ADDENDUM 1

Date: July 10, 2026.

Owner: Charleston Area Regional Transportation Authority (CARTA).
Project: Shipwatch Square Transit and Workforce Development Center

Engineer: HDR Engineering of the Carolinas, Inc.
— 4400 Leeds Avenue
Suite 450
North Charleston, SC 29405

Sheet Number
C-401

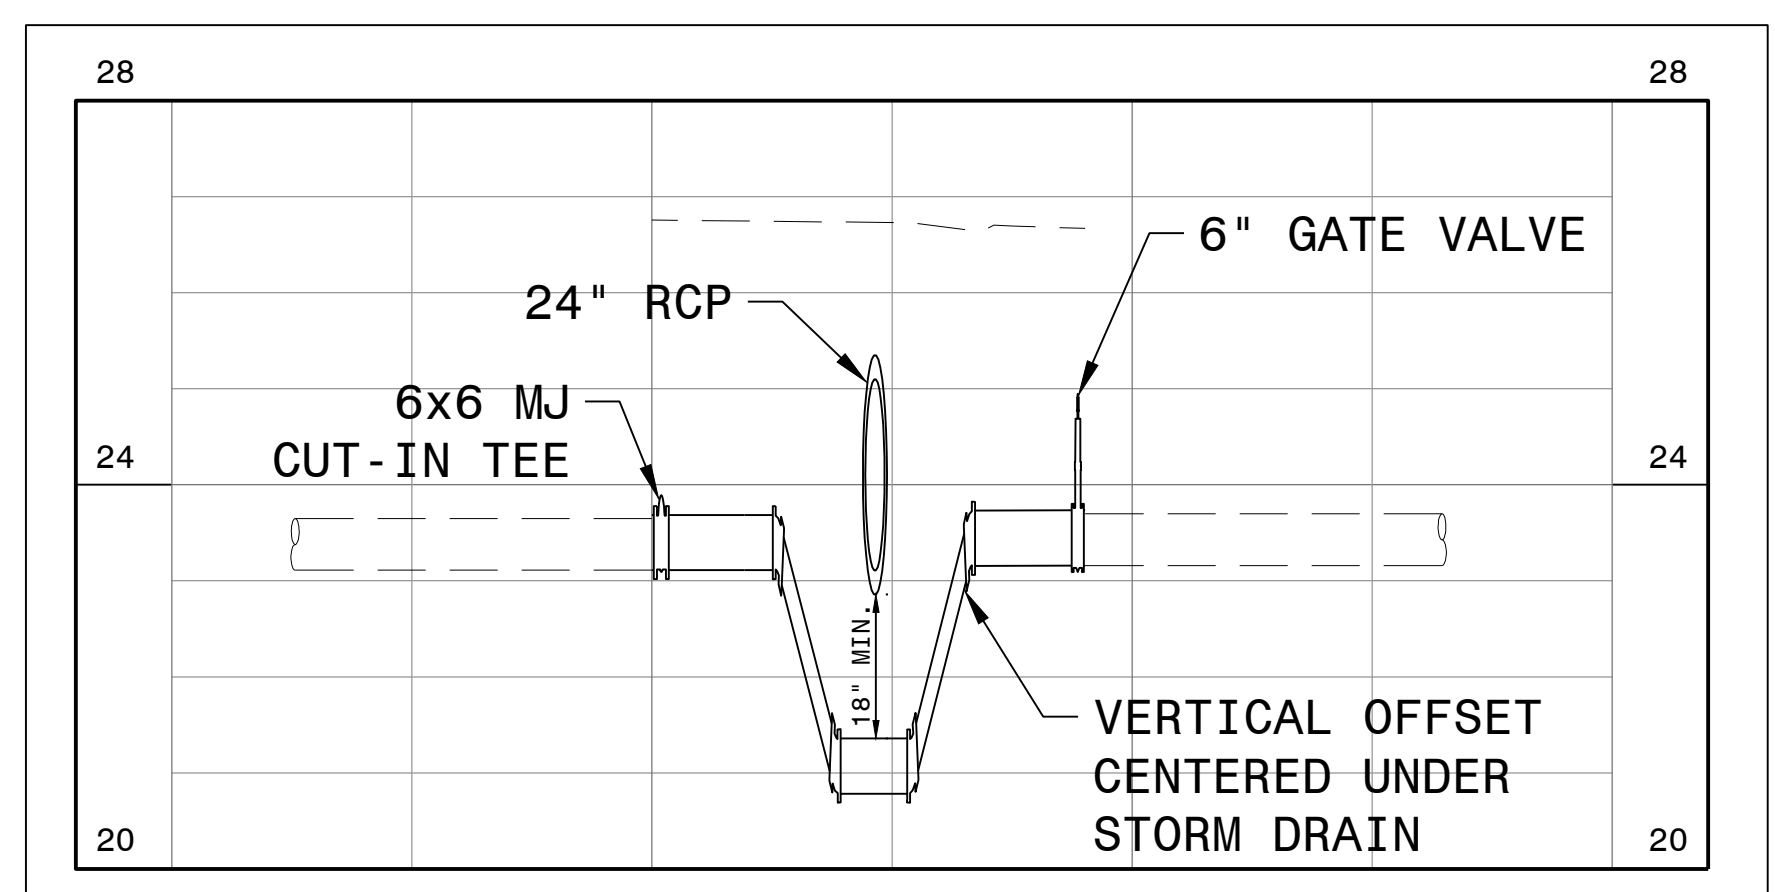
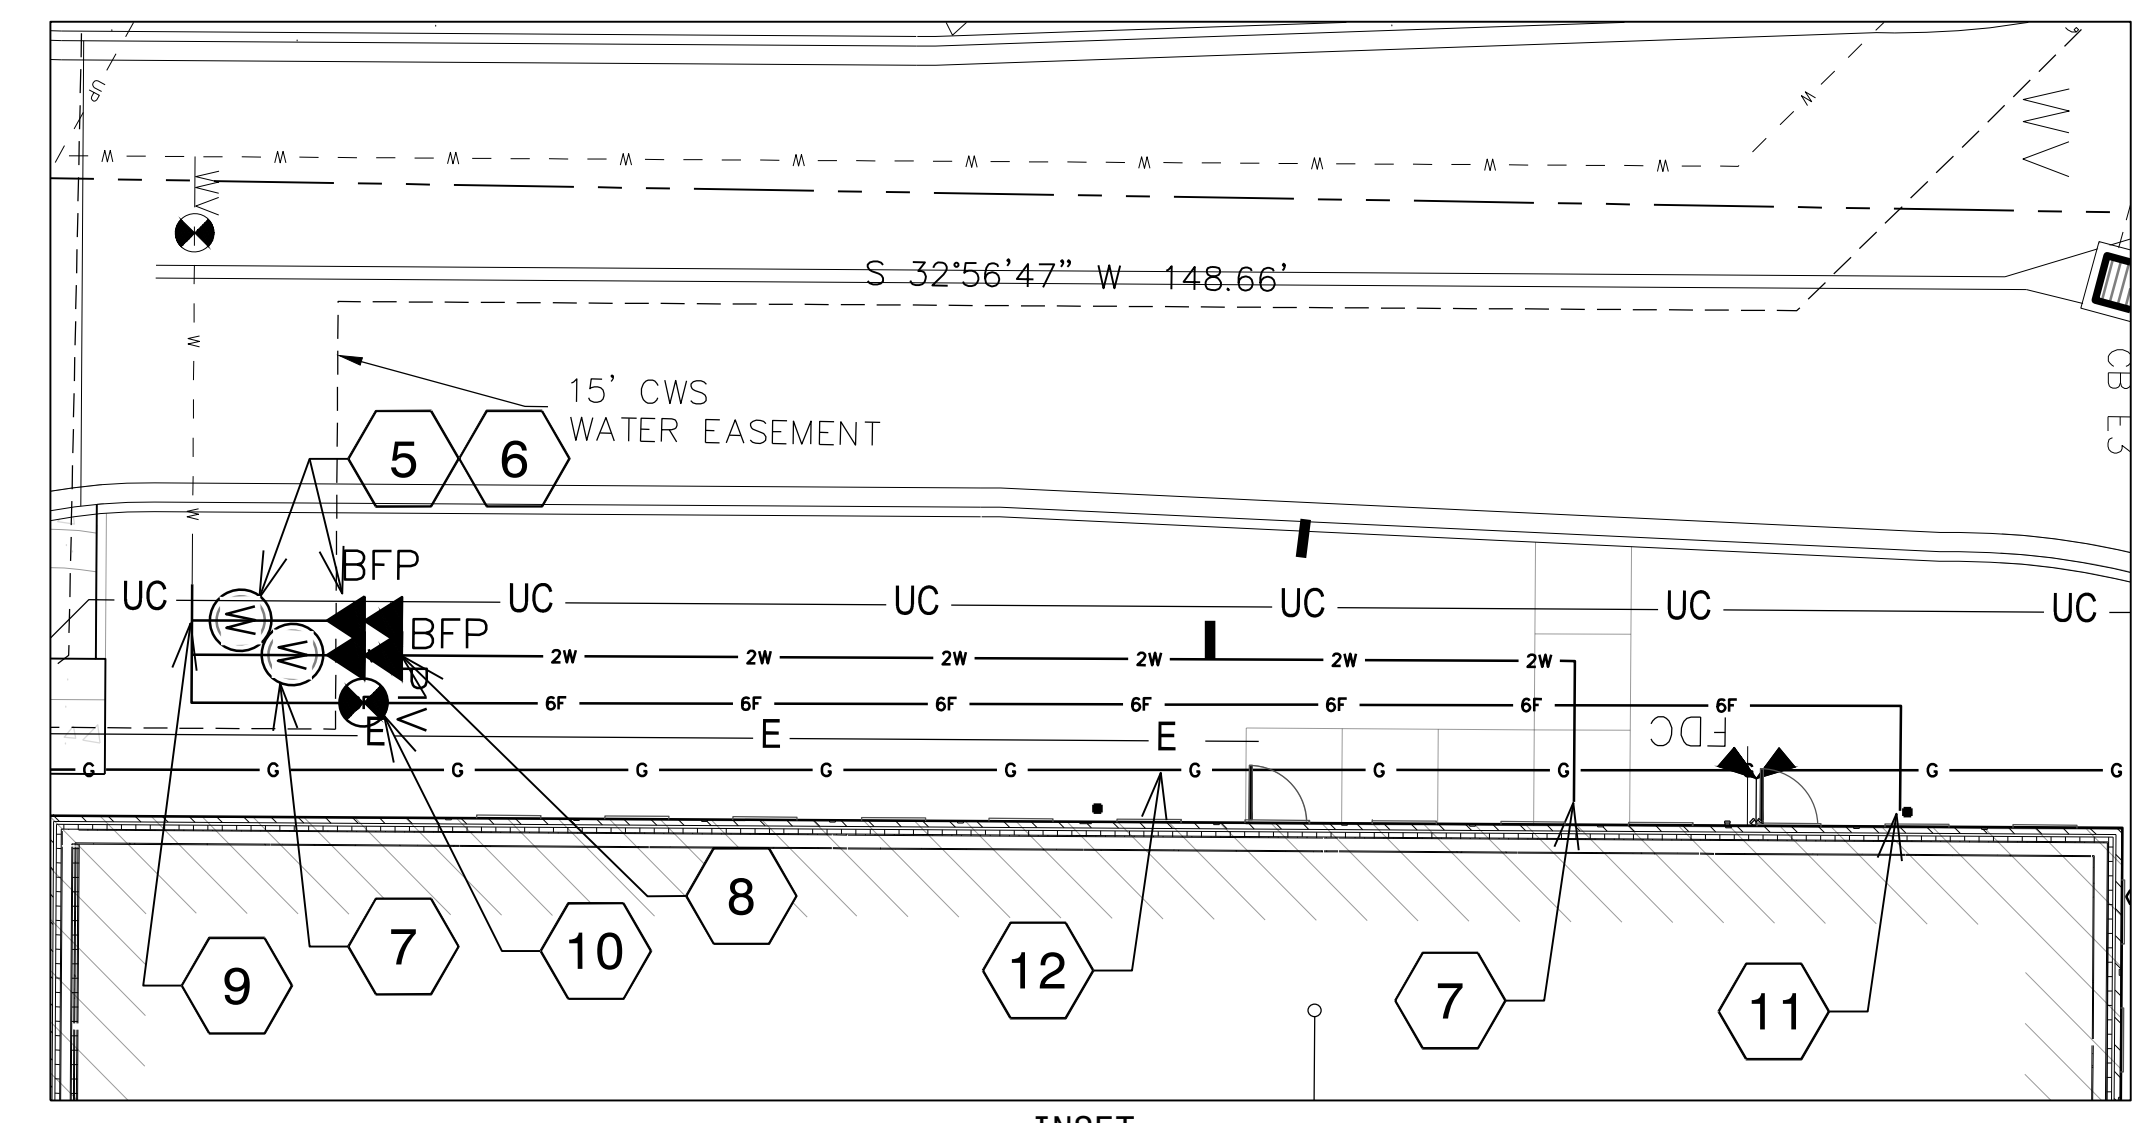
- A. Drawings listed in this section are reprinted at full size as an attachment to this Addendum.
- B. Sheet C-401:
 1. Revisions to water service at the direction of Charleston Water.
- C. Sheet C-403:
 1. Revisions to water service at the direction of Charleston Water.
- D. Sheet C-506:
 1. Revisions to water service at the direction of Charleston Water.
- E. Sheet A-102:
 1. Callout added for new enlarged plan B6/A-405 showing stacking of manually operated partition.
- F. Sheet A-151:
 1. Reflected ceiling plan revised to indicate 1'-0" wide gypsum soffit to accommodate track for manually operated partition.
- G. Sheet A-405:
 1. New plan detail B6 added, showing pocket of manually operated partition.
- H. Sheet A-501:
 1. Revisions to detail C1 correcting lintel type in conformance with Structural drawings and providing aluminum closure trim at window head.

B6 PLAN @ SECOND FLOOR OPERABLE PARTITION
1/2" = 1'-0"

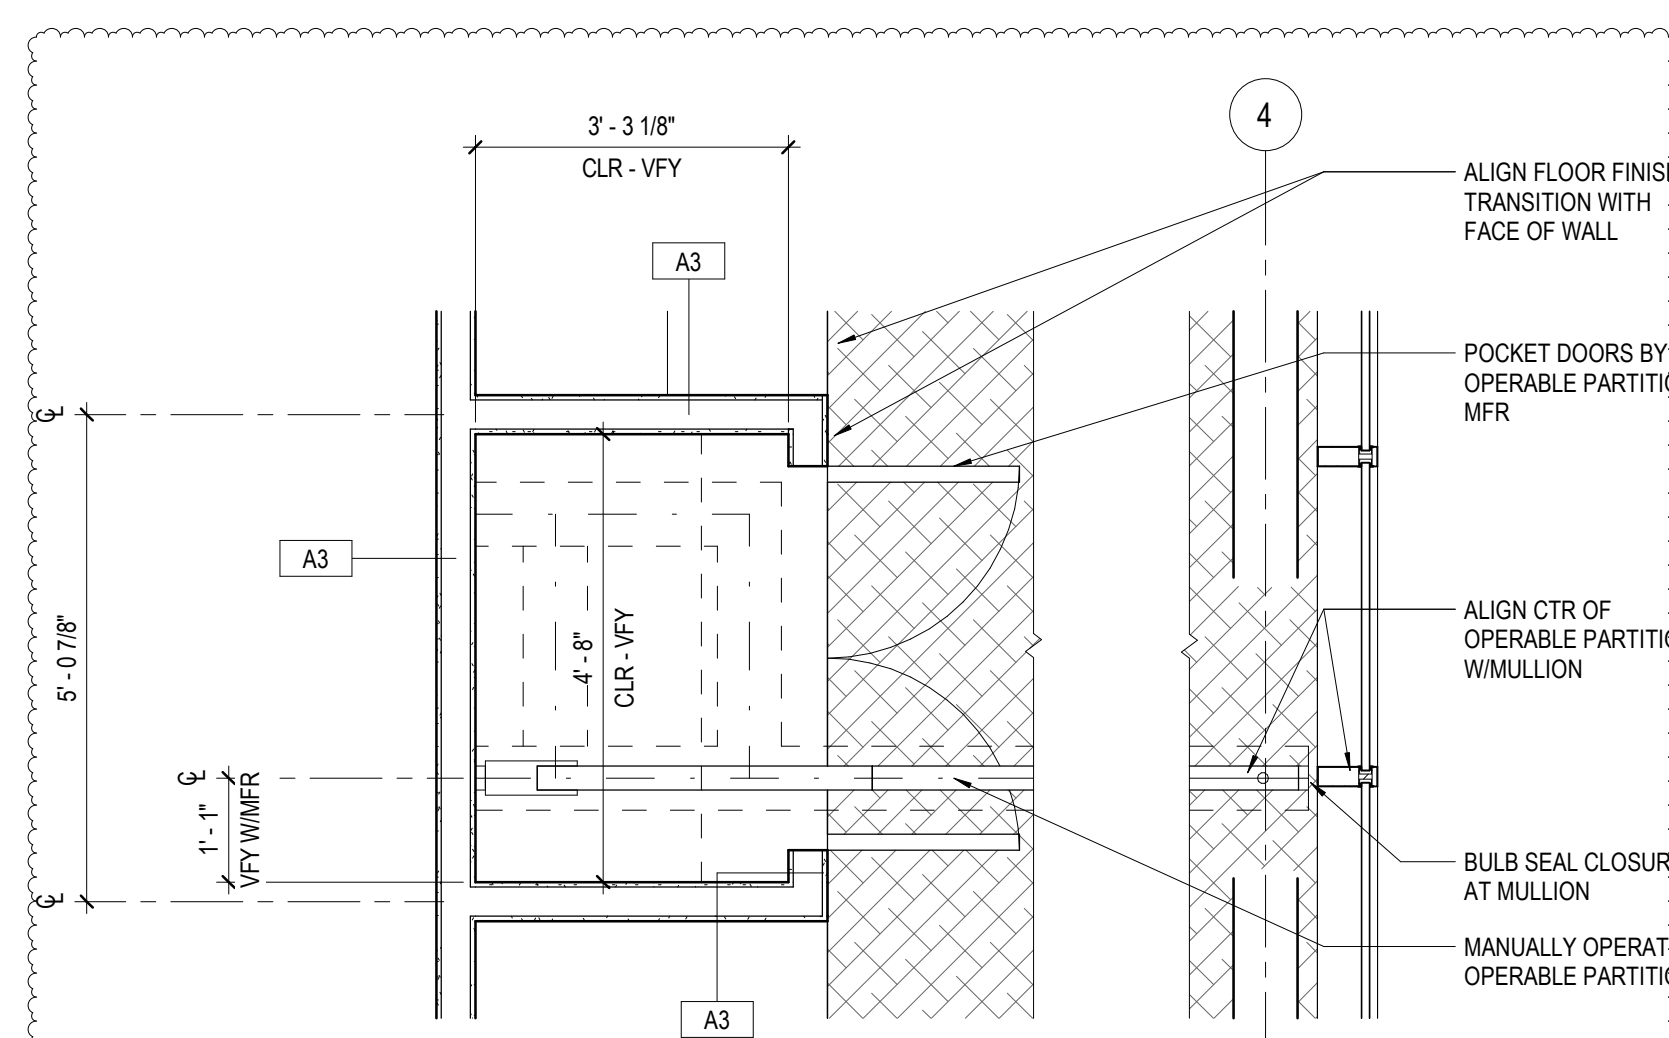
13. *There are two specification sections for the operable partition Scope (102239 and 102241) but only one operable partition. The models specified are completely different. Please clarify which is required - the single panel Acousti-Seal system from 102239 or the Acousti-Clear glass system from 102241.*
There are two operable partitions, and yes, they are very different. The two specification sections correlate with them: 10 22 41 is located in the first floor between 111 Transit Waiting and 118 Conference, shown on A-403, whereas 10 22 39 (Single Panels) refers to the single-panel, manually operated partition on the second floor separating 204 Training and 205 Training (see A-102.) We include in this Addendum an enlarged plan dimensioning the closet the panels stack in.

C3 BRICK VENEER PARAPET WALL @ COPING
1 1/2" = 1'-0"

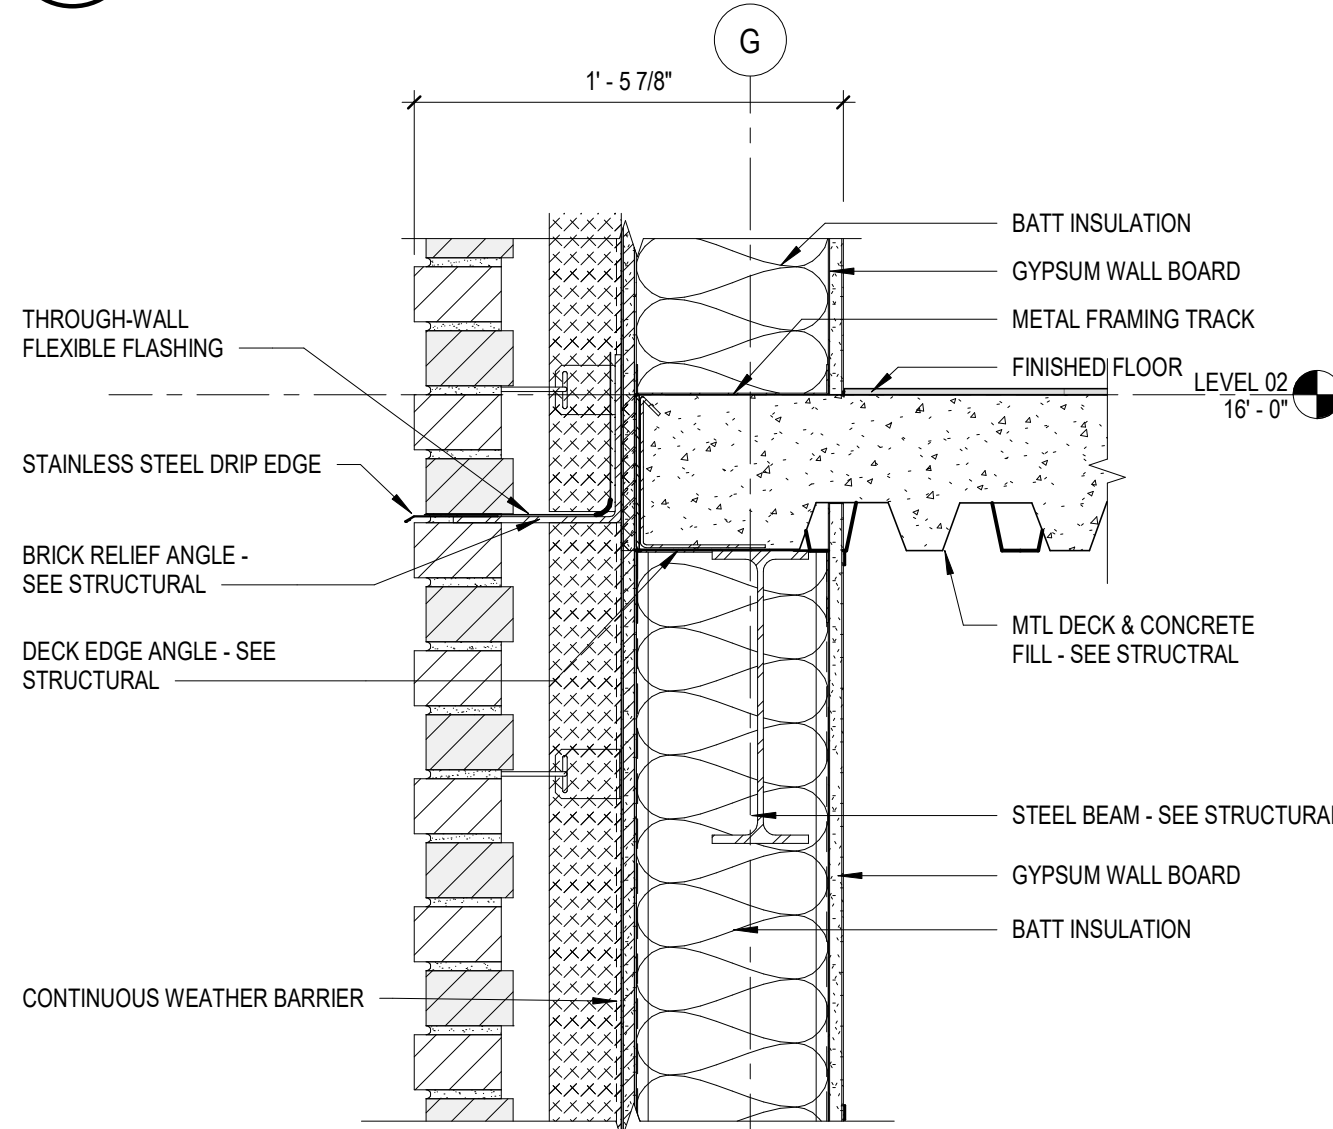
- c. *Interior framing not exposed to view – SP3 cleaned and primed with standard shop primer.* **Correct.**
 - d. *Roof parapet framing (ref. C3/A-501) partially exposed – SP3 cleaned and shop primed with S.W Pro-Cryl.* **Correct.**

C1 TYP. WINDOW HEAD @ BRICK VENEER
3" = 1'-0"

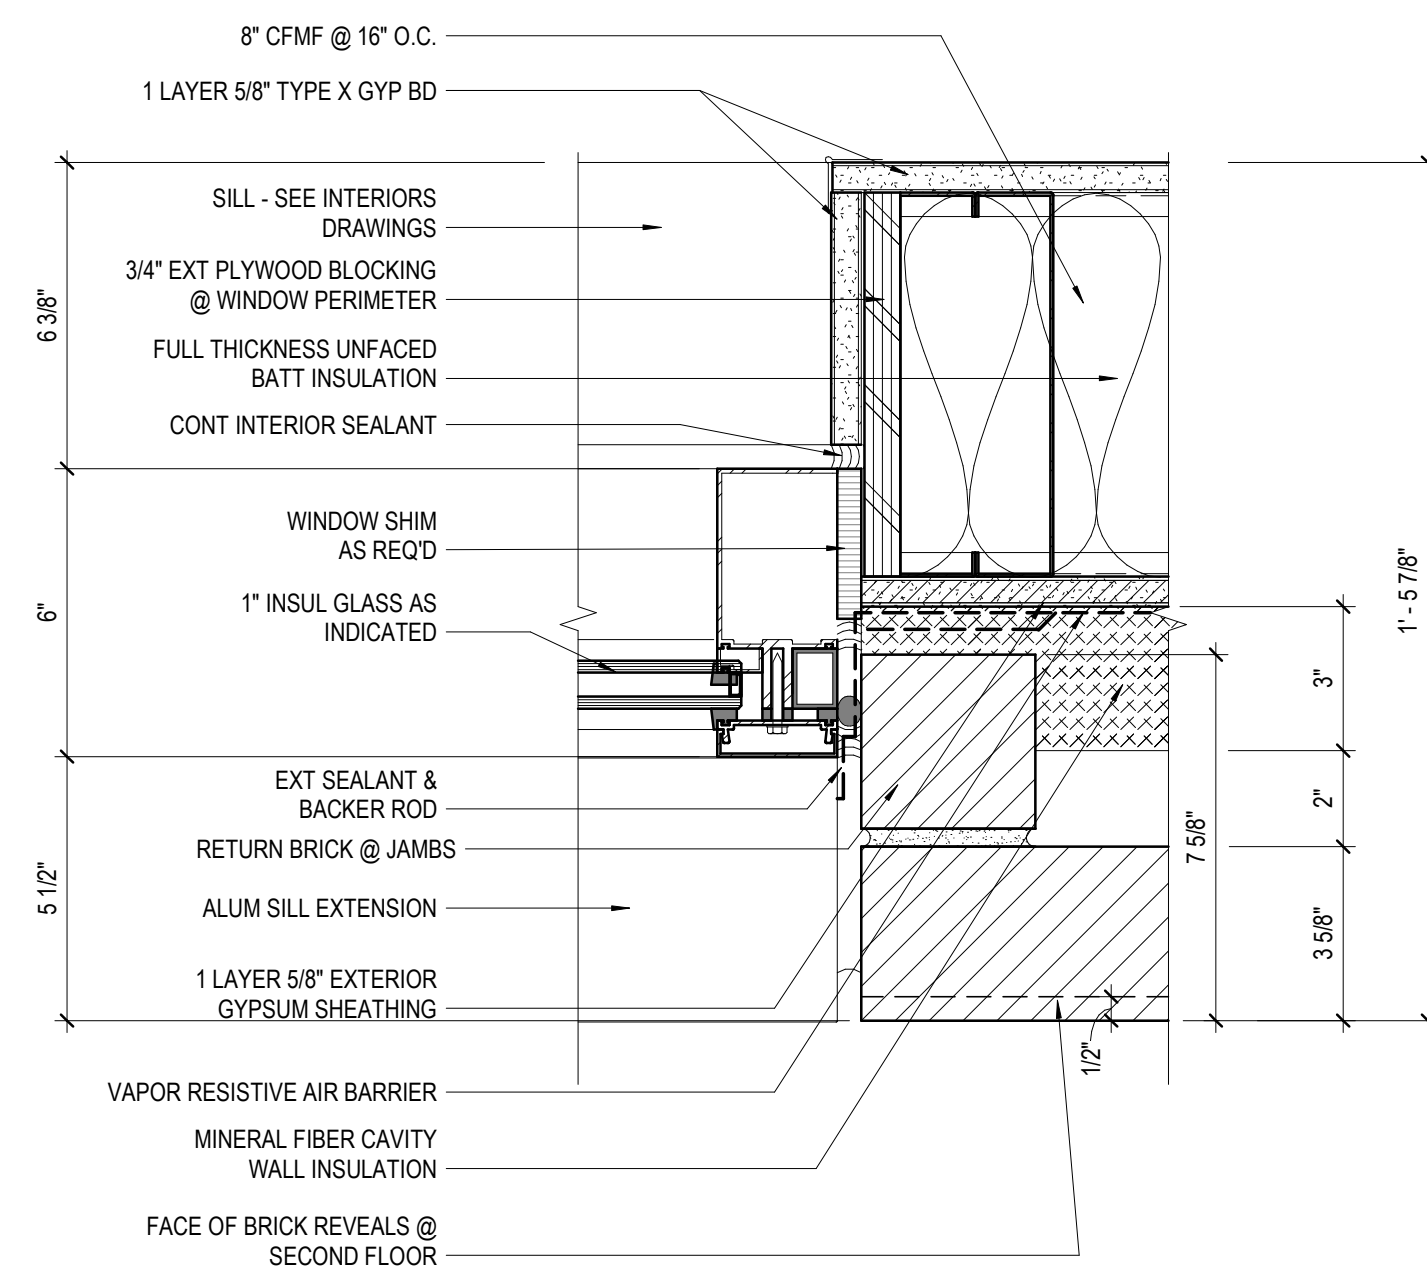
6. *The vertical bracing and columns at grid line 4 are interior and exposed to view; should this framing be AECS cleaned.*
Yes.
 7. *Loose lintel shown as typical on C1/A-501 is different from the loose lintels show on the structural lintel schedule C4/S-993.*
Detail C1/A-501 has been corrected as noted below in "Changes to Drawings."
